Application for Works Approval

Works Approval Number	W6433/2020/1
Applicant	Northern Star (Kanowna) Pty Ltd
ACN	010 511 789
File Number	DER2018/001042-3~75
Premises	<p>Kanowna Belle Gold Mine Yarri Road KANOWNA WA 6431</p> <p>Part of Mining Tenements: M27/18, M27/22, M27/23, M27/37, M27/49, M27/57, M27/92, M27/103, M27/122, M27/123, M27/127, M27/159, M27/164, M27/232, M27/245, M27/287, M27/420 and L27/62, L27/83 and L27/87.</p> <p>As defined by the premises maps attached to the issued works approval.</p>
Date of Report	13 May 2021
Decision	Works approval granted

Figure 5: SWL – TSF2 western monitoring wells

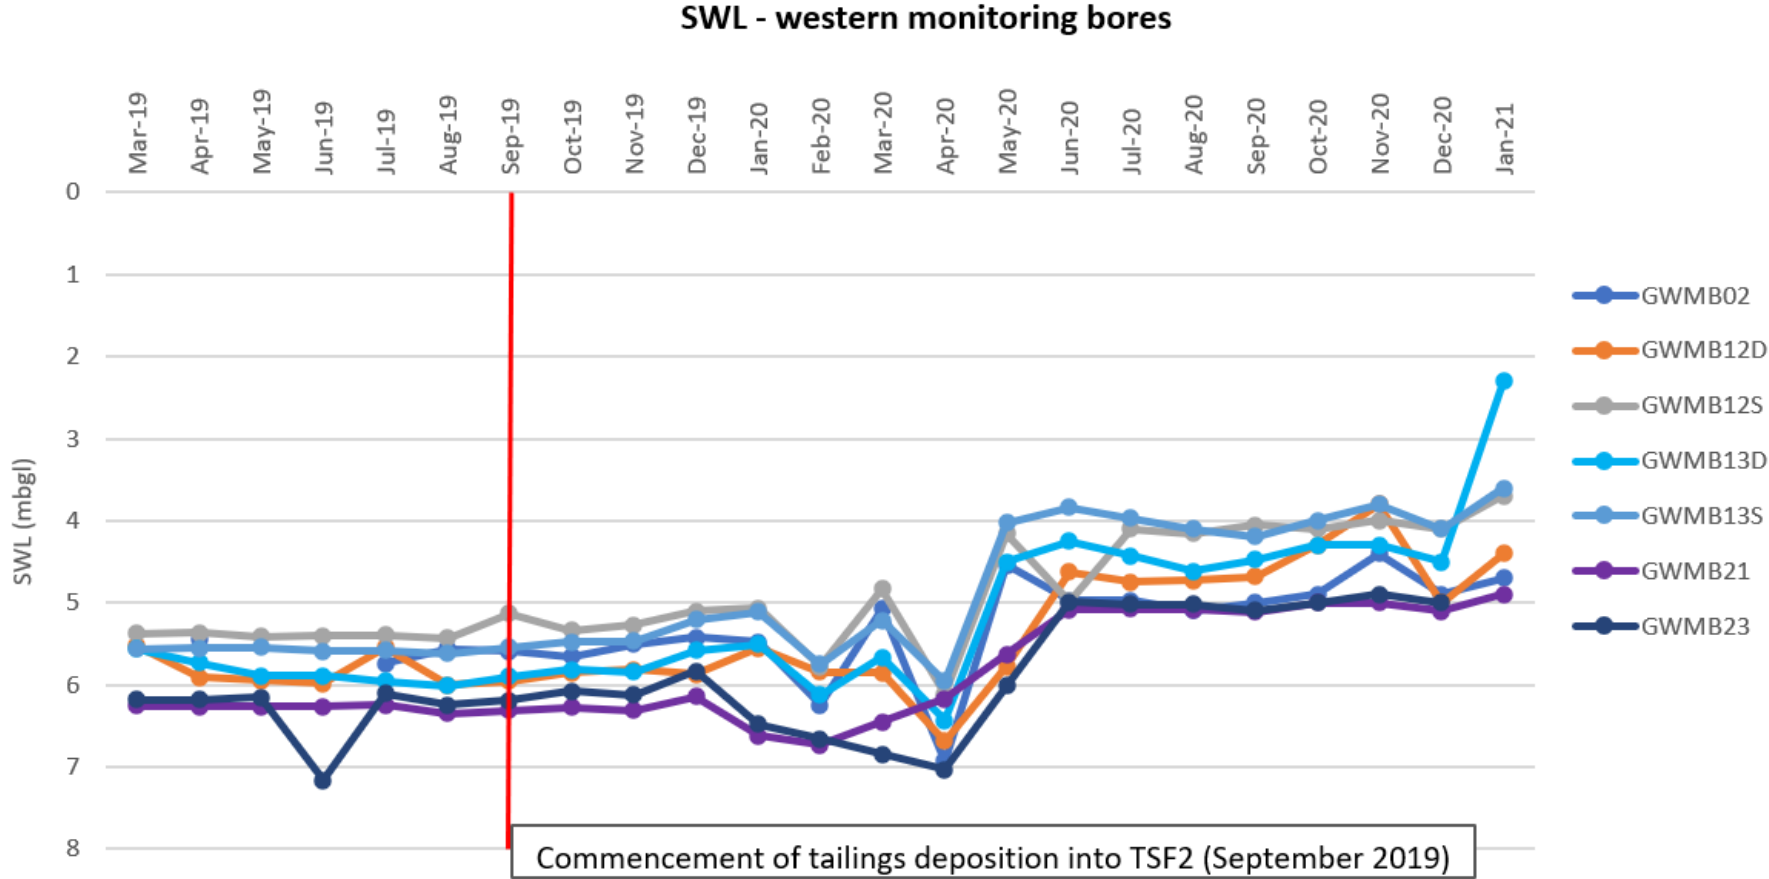
As demonstrated in Figure 5, Figure 6 and Figure 7 (Appendix 4), the groundwater levels within monitoring wells located to the west, north and east of TSF2 have risen since August 2019 in response to the commissioning and deposition of tailings into TSF2.

The shallowest groundwater level of 2.3 mbgl was observed in groundwater monitoring well GWMB13D (located immediately west of TSF2) in January 2021 (Figure 5). As of January 2021, groundwater levels in several groundwater monitoring wells located immediately west and north of TSF2 are within 4 mbgl (Figure 5 and Figure 6).

- requirement to install and have operational, the five new TSF2 seepage recovery bores at least 90 calendar days from the commencement of time limited operations for Cell 2. The condition includes seepage recovery bore design and construction/installation requirements. These requirements have been imposed to ensure the seepage recovery bores demonstrate

sufficient recovery yields and that a more rapid approach is actioned to manage seepage due to the notably shallower SWL in groundwater monitoring wells surrounding TSF2 (Condition 3).

Figure 10: TDS – TSF2 eastern monitoring wells

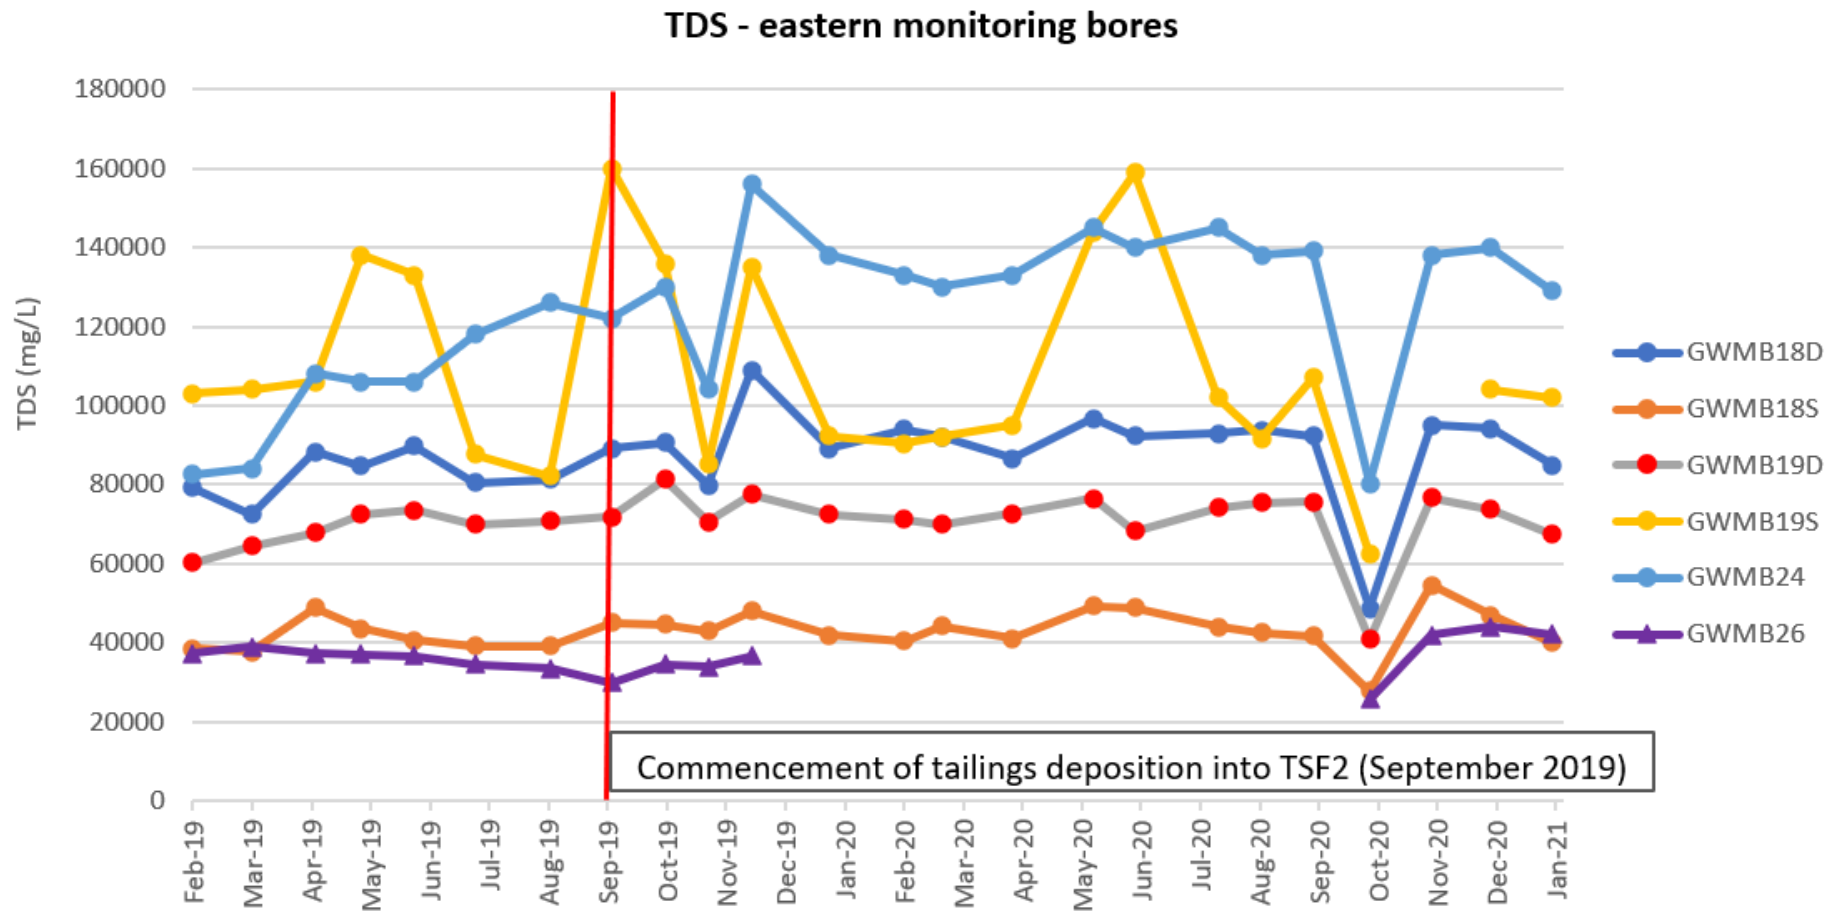
Since the commencement of tailings deposition into TSF2, the highest TDS levels have been observed in GWMB19S (located immediately east of TSF2) with 160,000 TDS in September 2019 and 159,000 TDS in June 2020 (Figure 10).
